RE: RESPONSE TO COUNCIL INFORMATION REQUEST FOR A MULTIPLE DWELLING (4 TOWNHOUSES) UPON LAND LOCATED AT 5 ROSEGLLEN STREET, GREENSLOPES – COUNCIL FILE REFERENCE A006910166.

Enc Response to Information Request

Figure 1: Original Proposal

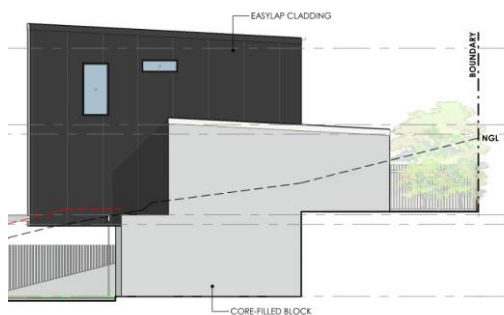
1. The height, position and design of the proposed built to boundary wall along the eastern side boundary is not considered to meet AO7.2/PO7 of the Multiple dwelling code. The two storey 5.8m high wall is considered to impact the amenity of the neighbouring property abutting the eastern side boundary. The proposed 'Media' room being setback 2.99m to the rear boundary in lieu of the 6m requirement is also considered to impact the neighbouring property abutting the rear boundary. It is evident that that proposed 'Media' room is not a non-habitable room or space.
 - a. Provide amended plans that depict a revised built to boundary wall design consistent with PO7 of the Multiple dwelling code.

A revised built to boundary wall is proposed to ensure that the development is consistent with PO7 of the Multiple dwelling code. In lieu of a media room built to the boundary, the open aired alfresco / private open space area has been enlarged and now encompasses the old media room space. To further assist Council with their assessment, the project architects have illustrated the extent of below ground boundary wall on Elevation B (Drawing Number DA6.1). As illustrated, a built to boundary retaining wall is maintained along this section of the boundary to manage the crossfall and natural topography of the site. A comparative perspective is provided below to illustrate the reduction in proposed boundary walls. Based on a compliant 6m rear setback for Townhouse 4 and replacement of built to boundary floor space with private open space, the design satisfies PO7 of the Multiple dwelling code.

Figure 3: Proposed rear and north-eastern setbacks

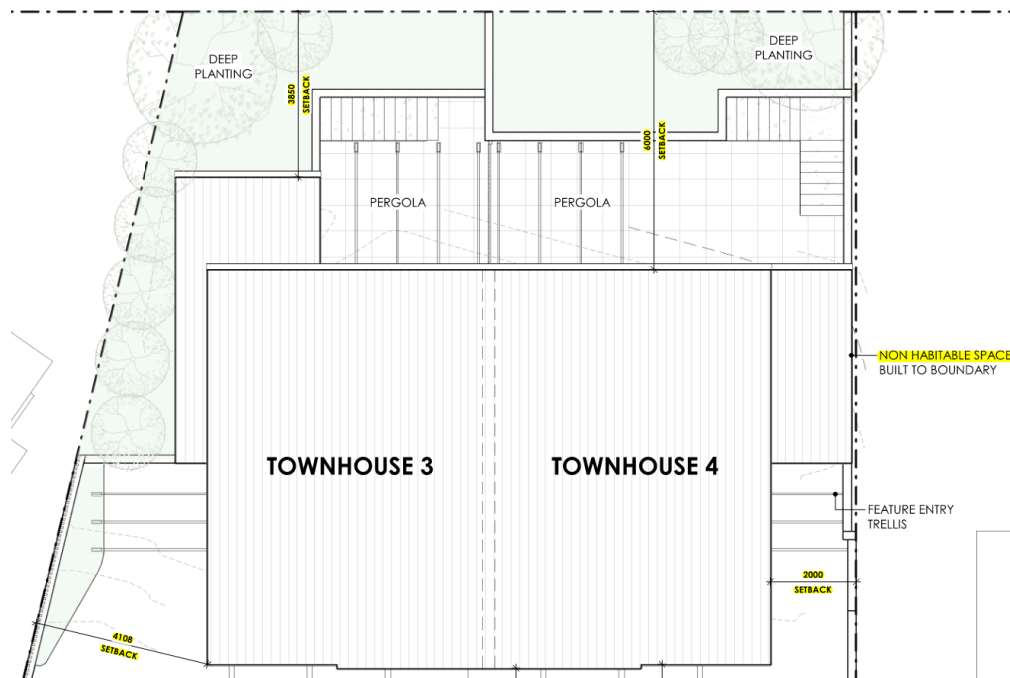
- a. Provide a greater building separation between internal buildings in accordance with AO14.1/PO14 of the Multiple dwelling code (3m minimum required).
- b. Relocate the internal stairs and relocate habitable rooms along the perimeter of the building with no habitable rooms opposing one another internally.
- c. Provide greater setbacks at the rear and to the north-eastern portion of the site where built to boundary components are proposed as mentioned in Item 1.
- d. Provide privacy diagrams indicating the habitable windows of the rear adjoining neighbour and the adjoining neighbour abutting the eastern side boundary. Screening may be required.

The revised development footprint incorporates increased setbacks to the rear and north-eastern boundaries. The rear setback now achieves a compliant 6 metre separation, improving outlook, privacy and access to natural light for both the proposed development and adjoining properties. Furthermore, as detailed in our response to item 1, the previously proposed built to boundary wall is significantly reduced and contains private open space in lieu of a Media Room.

Figure 4: Frontage retaining wall section drawing

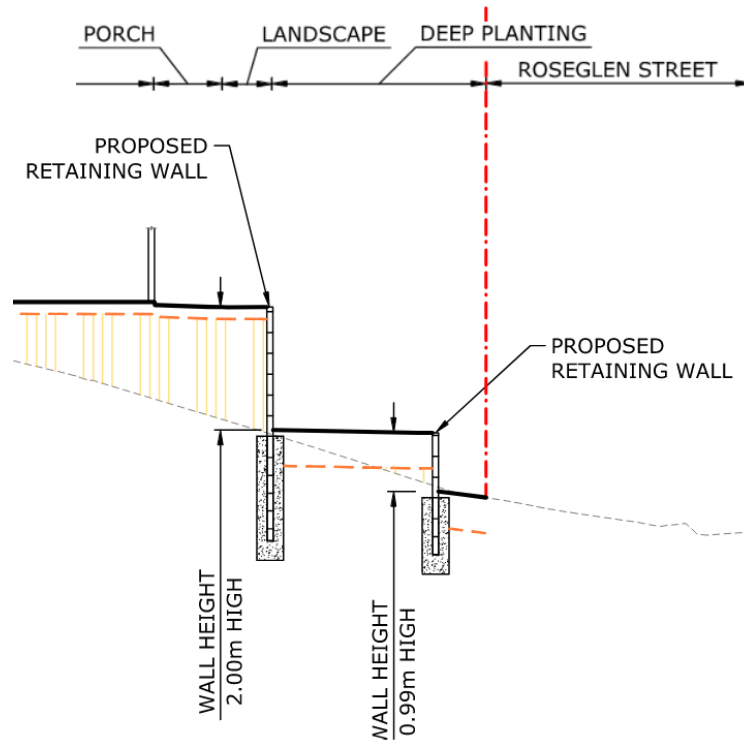
- c. *Remove the proposed front pergola area, to facilitate subtropical shade tree planting along the frontage;*
 - d. *Provide cross sections to demonstrate the extent of retaining walls and their footings and drainage to determine the extent of unconstrained landscape areas.*

- Cross-sections illustrating the retaining wall configuration, including footings and drainage, are provided in the enclosed civil drawings prepared by Concept Engineers and below in figure 4 to clearly demonstrate the extent of retaining infrastructure along the frontage.

- Minor encroachment from retaining wall footings, stormwater discharge pipe and an existing sewer main occurs within the frontage landscape zone. Importantly, the stormwater and retaining wall infrastructure does not significantly encroach into the deep planting zone. These obstructions do not limit root growth or compromise large shade trees.

The sewer main is located at approximately 20.74m AHD, which is approximately 2m below the finished surface level of the deep planting zone. At this depth, the infrastructure will not materially impede root growth of the proposed subtropical shade trees. Tree planting will be positioned to maintain appropriate offsets from services while still enabling adequate soil volume for healthy tree growth.

Figure 5: Side Elevation B internal height clearance notation.

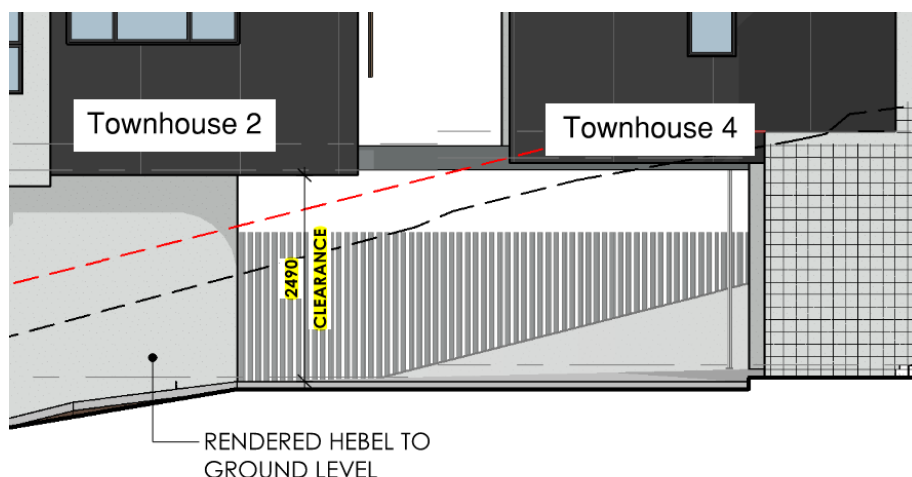
13. In order to address PO1, PO3, PO9, PO13 and PO15 of the Transport, access, parking and servicing code, clearly demonstrate on the revised plans and sections, that there will be a clear height clearance of a minimum of 2.3 metres above the internal driveway, vehicle manoeuvring areas and garages, clear of all intrusions and attachments to the building.

All vehicle manoeuvring and parking areas achieve minimum height clearance requirements. Section diagrams within the revised architectural plans clearly notate a minimum clearance of 2.4m to internal driveway areas.
